QUEENSLAND FLOODS COMMISSION OF INQUIRY
REVIEW OF HYDRAULIC MODELLING
FINAL REPORT

REVIEW OF HYDRAULIC MODELLING QUEENSLAND FLOODS COMMISSION OF INQUIRY

Project Review of Hydraulic Modelling Queensland Floods Commission of Inquiry		Project Number 111024
Client QLD Flood Commission of Inquiry		Client's Representative Lisa Hendy
Authors Mark Babister Stephen Gray Rhys Hardwick Jones		Prepared by 
Date 28 JULY 2011		Verified by 
Revision	Description	Date
1	FINAL	JULY 11
2	FINAL (Revised 28/07/11)	JULY 11

Figure 1: Velocity Time Series (modelled) at Jindalee (SKM Model Version 1)

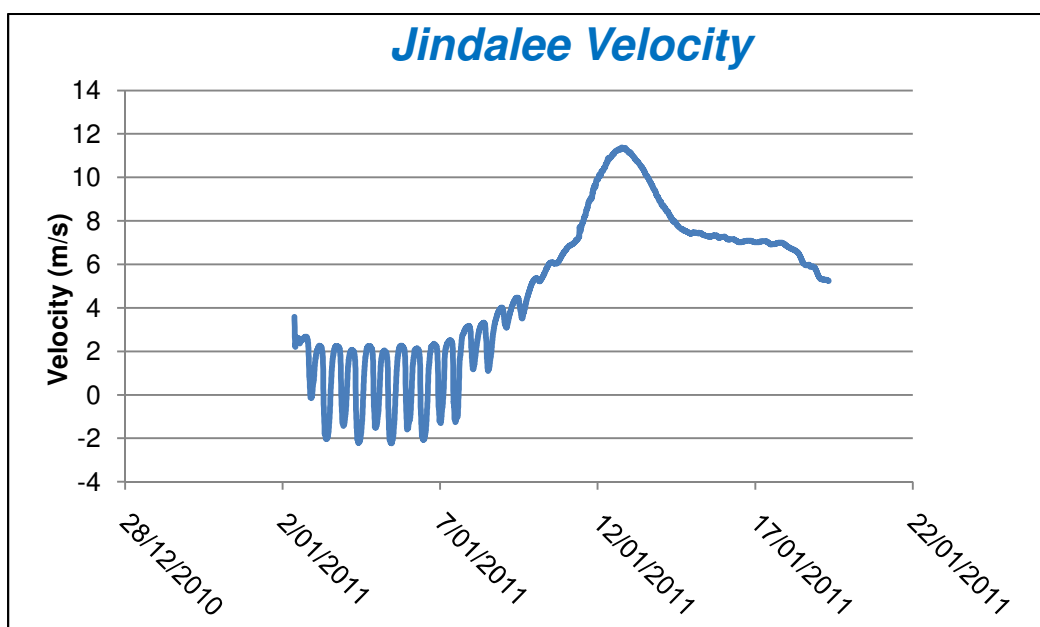
- 28 The WMAwater review of the Version 1 model found some issues with the model build which undermined the legitimacy of calibration and scenario runs as presented in the recent report by SKM and Seqwater (Reference 2). Figure 1 to Figure 4 demonstrate the issues which are summarised below:

- Flow velocities modelled were unrealistically high (cross-sectional average velocities greater than 10 m/s);
 - Model stability was poor;
 - Roughness values were artificially high, presumably to compensate for high flow velocities; and

- Run time was excessive.
- 29 Overall the issue which led to most problems in the model was the resistance approach used. In summary, there are two possible issues with the use of the “Resistance Radius” approach (as adopted in the Version 1 SKM model). First, when used in conjunction with relatively high flow zone multiplier values it leads to artificially constrained cross-sectional area within the processed value table of the cross-section (*.xns11) files used in Mike11. Second, the “Resistance Radius” approach is less suited to deep cross-sections with steep side slopes as are found in many locations on the Brisbane River. Through some combination of these two mechanisms very high mean velocities were modelled (see Figure 1). The high modelled velocities were approximately 4-5 times what was achieved using an alternative resistance formulation and compared to gauged velocities at Jindalee were demonstrably false. The high modelled velocities in turn seemed to exacerbate stability issues and require the higher roughness values observed in the model. Please note that velocities presented are average velocity over the entire modelled cross-section, not peak in-bank velocity.

Figure 2: Discharge Time Series (modelled) at Mt Crosby Bridge (Version 1)

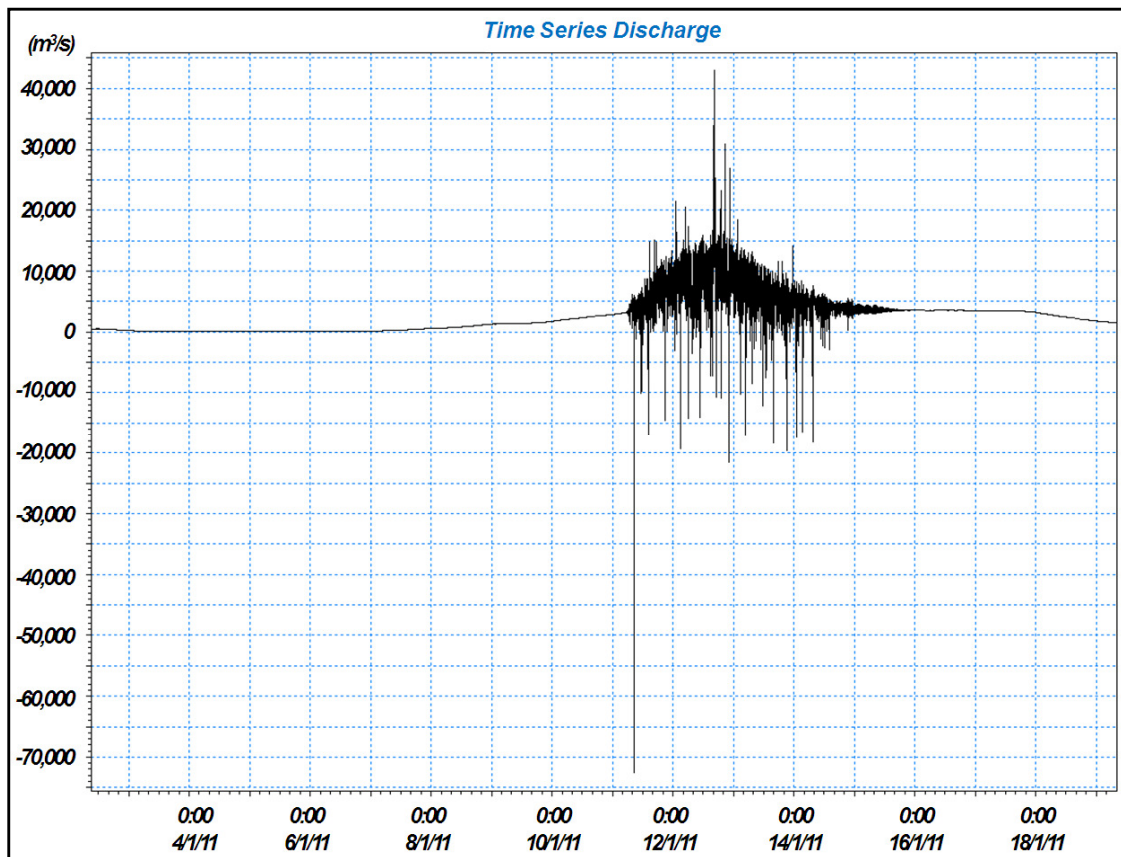
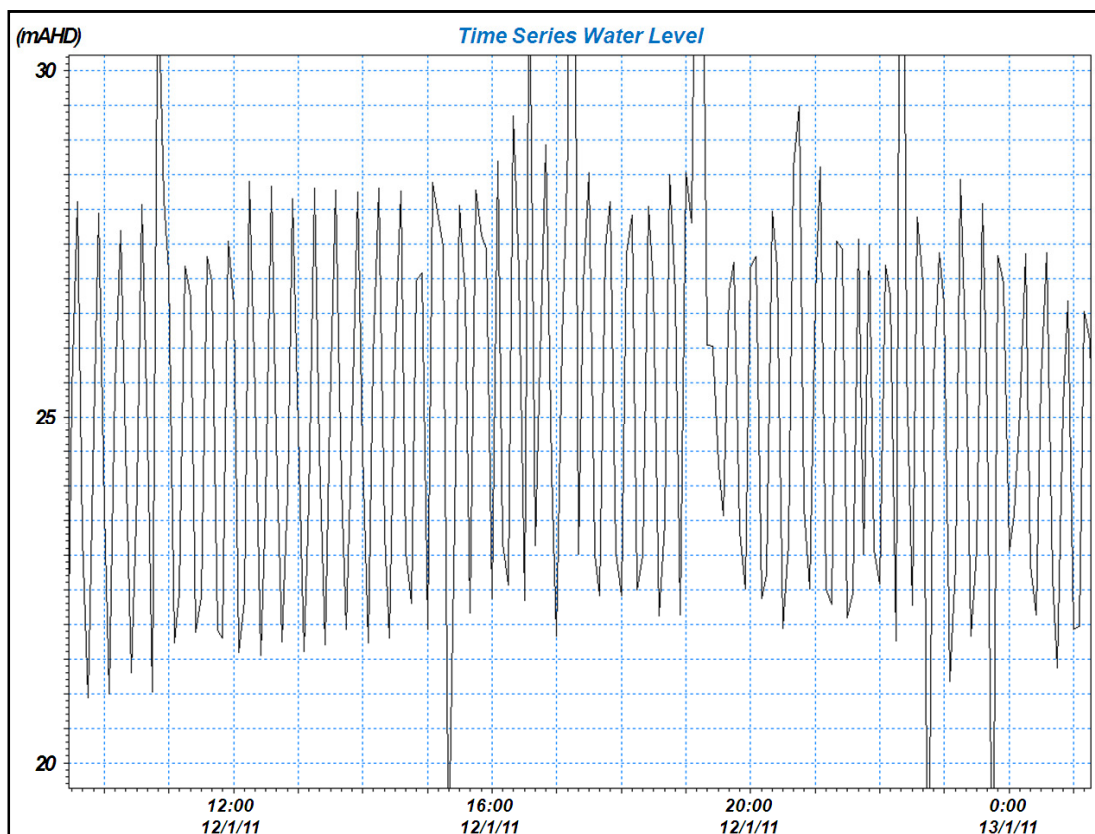
- 30 Figure 2 and Figure 3 indicate the Version 1 model's lack of stability with discharge fluctuating between 40,000 m³/s and negative 70,000 m³/s in Figure 2 (actual discharge peaks at approximately 9,000 m³/s) and the water level fluctuating between approximately 21 mAHD and 28 mAHD in Figure 3 (actual peak water level is approximately 26 mAHD). Note both results are at Mt Crosby Bridge and both results are indicative of the worst of the stability issues in the model.

Figure 4: Model Results (Version 1) at Port Office versus “Fixed” model results

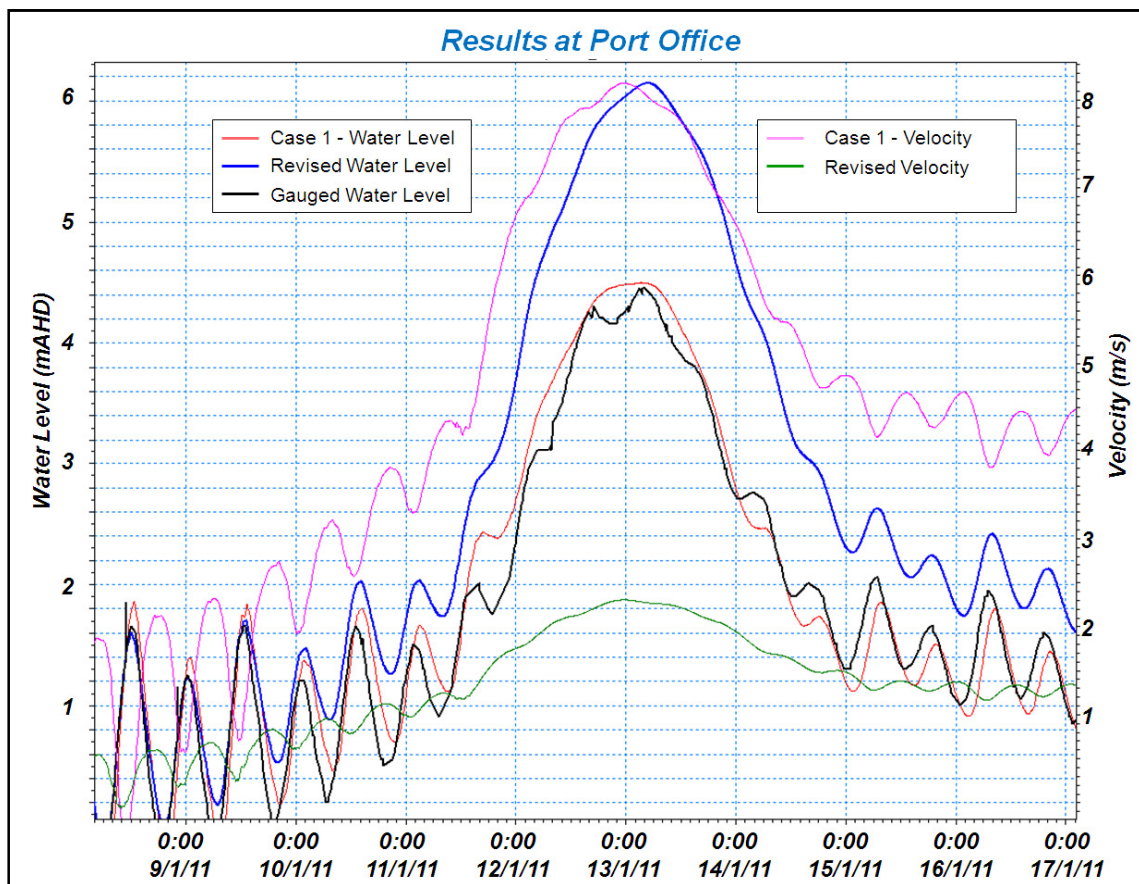
- 31 As part of the review process the Version 1 model was altered to a different resistance method and this reduced maximum cross-sectional average velocities in the Brisbane River from 10 m/s to approximately 2.5 m/s. The impact this change had on model results in the Version 1 model is shown in Figure 4. Note that whereas previously, with the unreasonably high velocities, the modelled water level was a good match for the gauged water level at Port Office, when the velocities are a more reasonable value (see “Revised Velocity” versus “Case 1 Velocity” in Figure 4), the modelled peak water level increases from 4.5 mAHD to approximately 6.2 mAHD. This demonstrates that the parameters used in the Version 1 model did not produce a reasonable match for both water level and velocity at the Port Office gauge. When there was a good match for water levels, velocities were too high, and when velocities were at a reasonable magnitude, water levels were too high.

Figure 5: Mike11 Cross-Section with insufficient floodplain detail

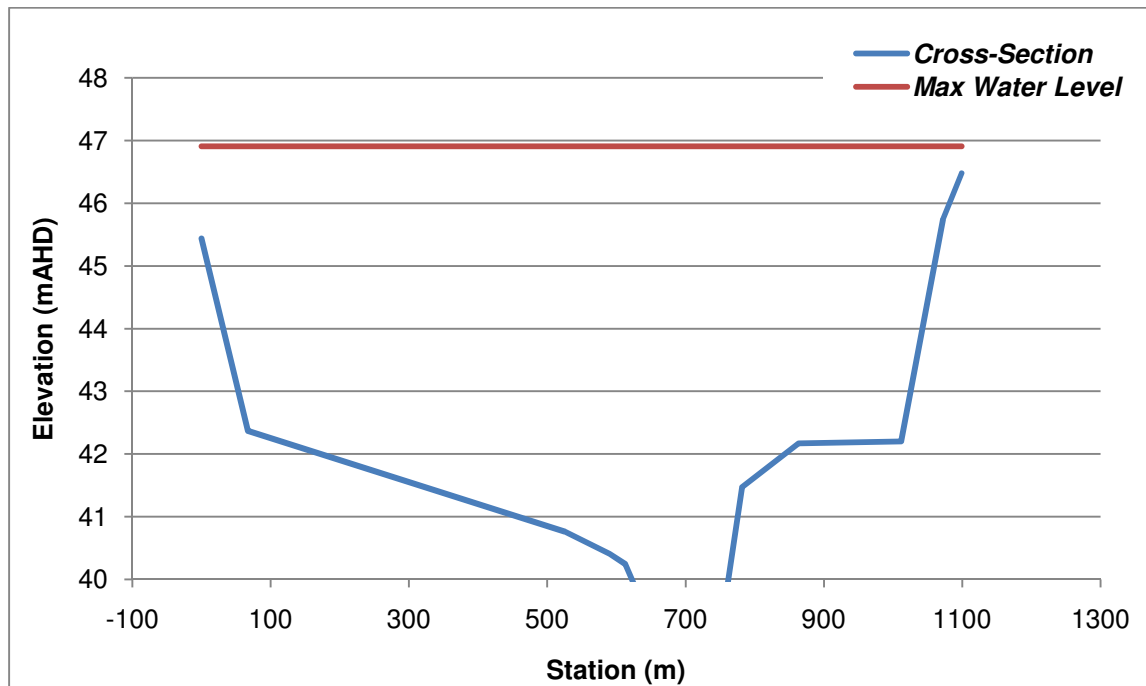
- 43 An issue noted with regard to the model cross-sections is that in some cases the cross-sections contain an inadequate amount of the floodplain and as such are subject to extrapolation error. This situation will typically overestimate peak flood level and lead to underestimation of system attenuation. An example is shown in Figure 5 for a cross-section at chainage 934,270 m on the Brisbane River, approximately four kilometres downstream of the Wivenhoe Dam outlet. Note that peak water level exceeds the defined topography. In such a situation Mike11 extrapolates vertically from the defined top left bank and top right bank. This issue was only observed in a small minority of model cross-sections and is unlikely to affect the model results significantly.

Figure 6: Comparison of gauged and modelled water level – Mt Crosby

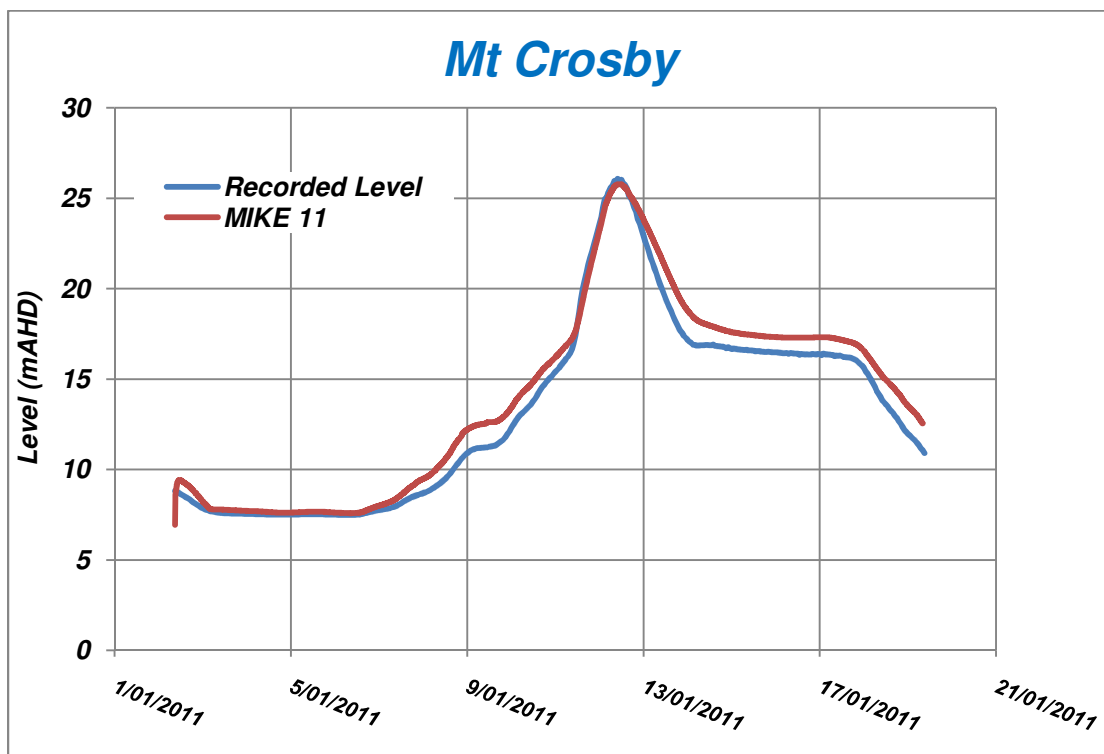
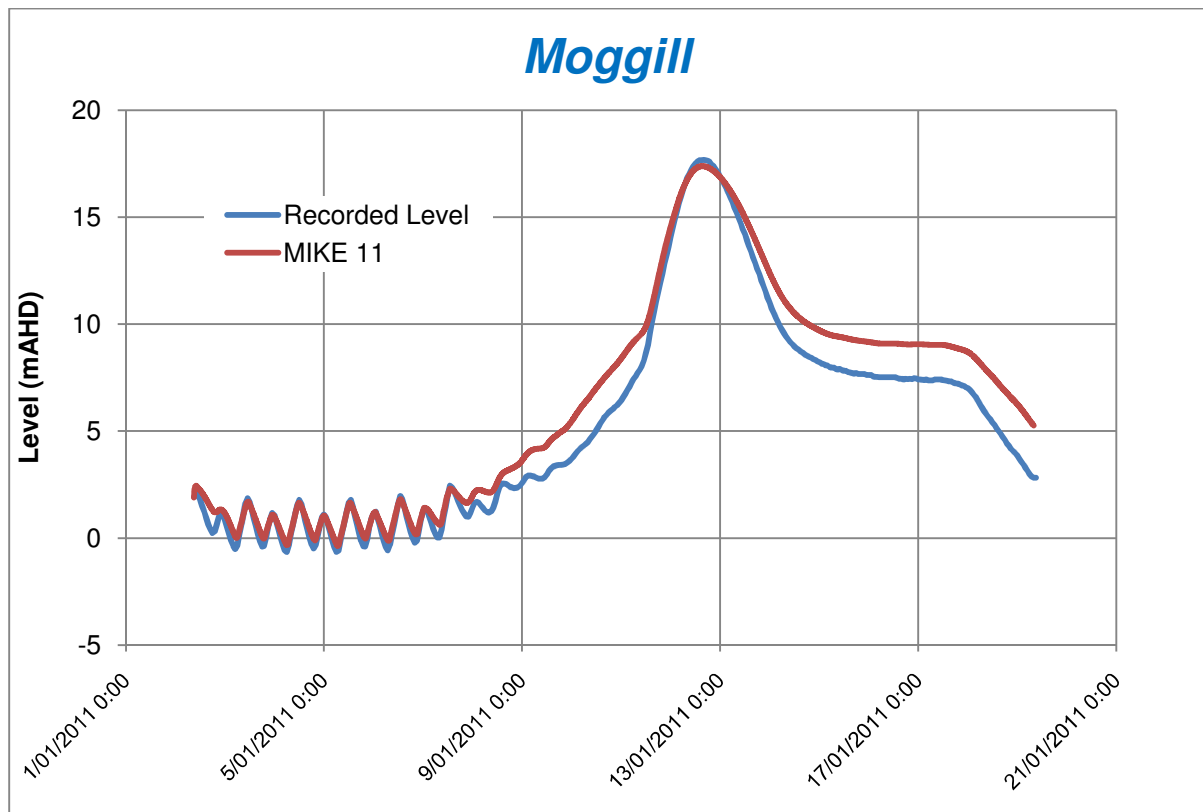
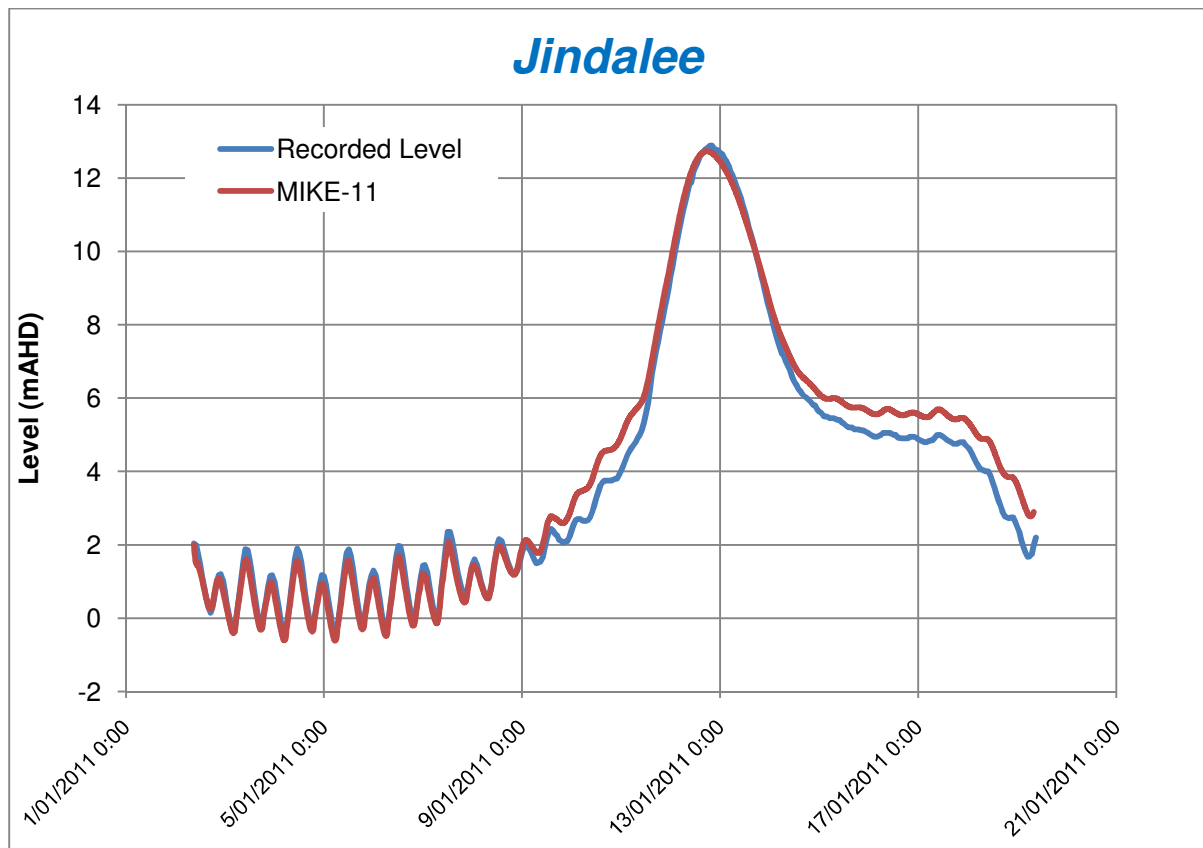
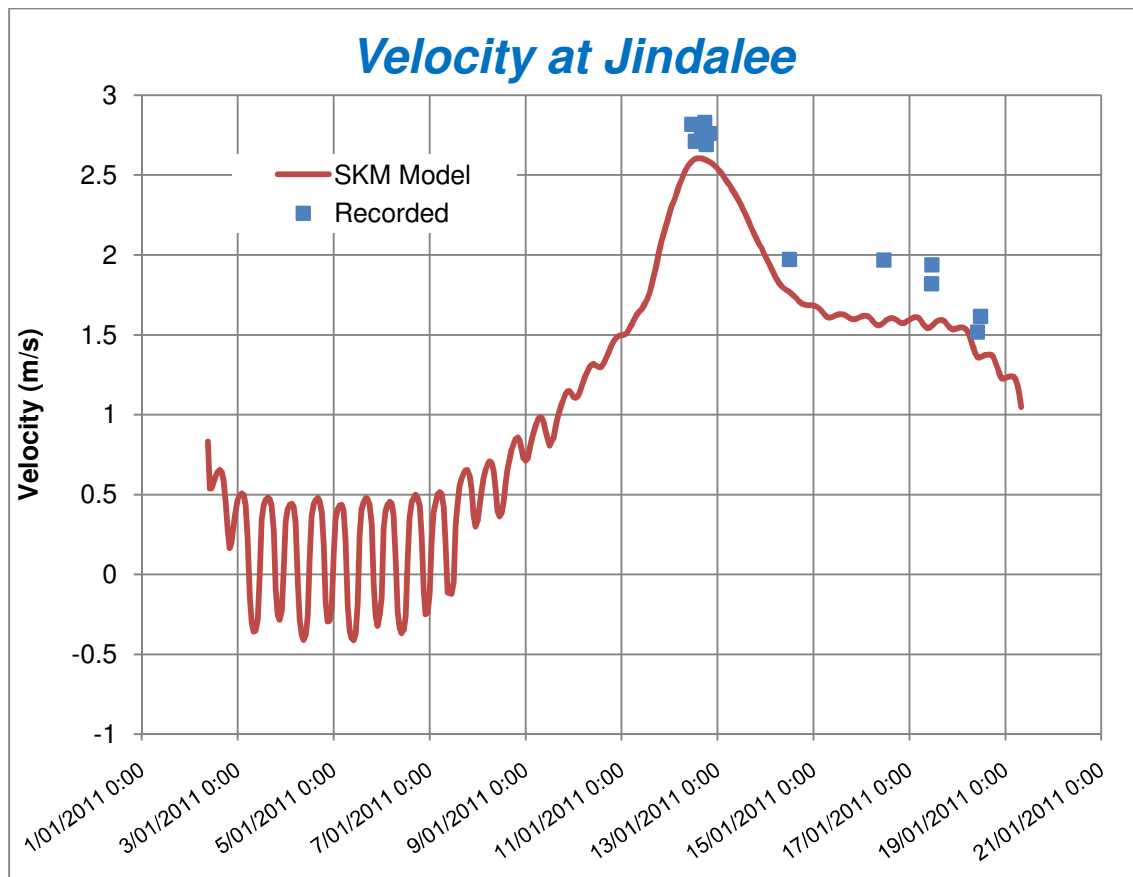
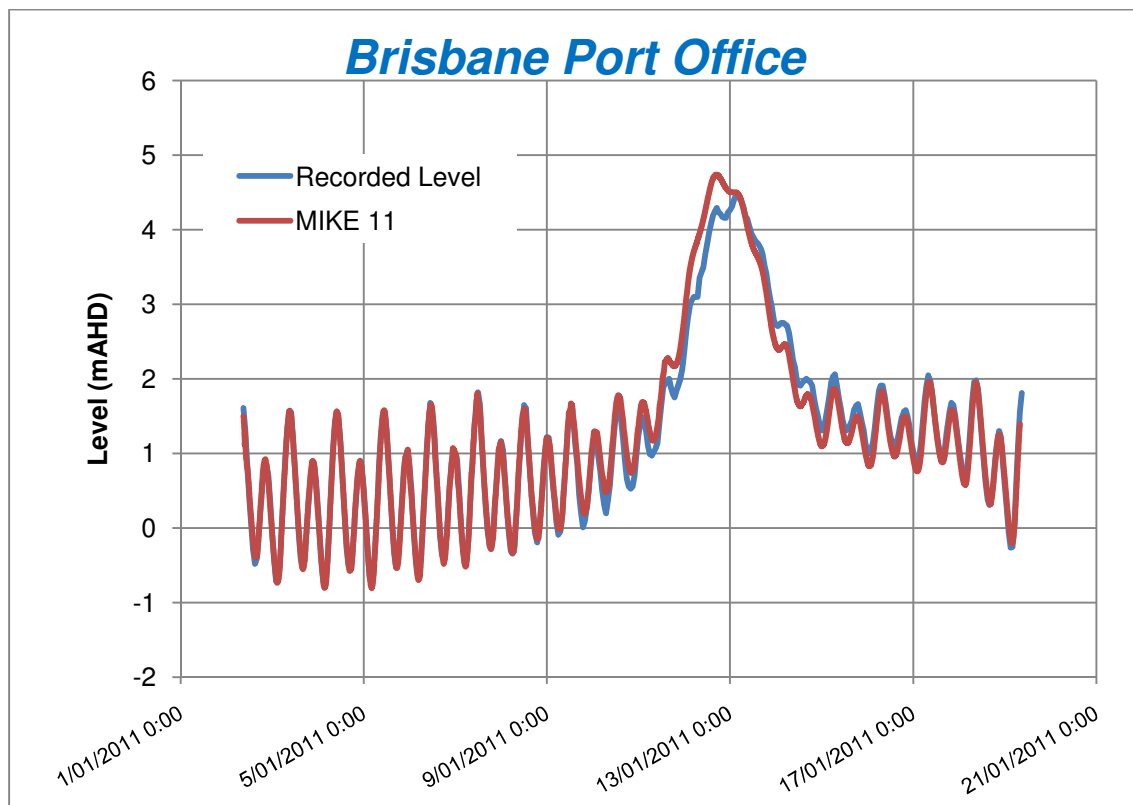
- gauged discharge at Jindalee during event; and
 - recorded water level at Moggil, Jindalee, Oxley and Port Office.
- 49 Figure 6 to Figure 10 describe the calibration result. Overall the match between gauged and modelled water level is excellent at Moggil and Jindalee, particularly in regard to peak behaviour. The match is very good at the Port Office although the modelled peak does occur too early at this location. The match to mean velocity between modelled and observed data is excellent. Modelled discharge at Jindalee is also well matched with the model estimating discharge at close to 10,000 m³/s, as per the gauging. The match to Mt Crosby is excellent but less relevant since this point was used to derive the input flow and also because it is located directly next to a major model boundary.

- 50 The model has a tendency to underestimate observed routing time, with the effect most evident at Port Office, the furthest distance (67 kilometres) downstream of Mt Crosby. The tendency of the model to have the flow arriving early relates to the likelihood that the model does not currently represent the storage of the system and resulting attenuation of flood flows, particularly between Jindalee and Port Office. The effect is slight however and likely exacerbated by the timing relative to the tide.
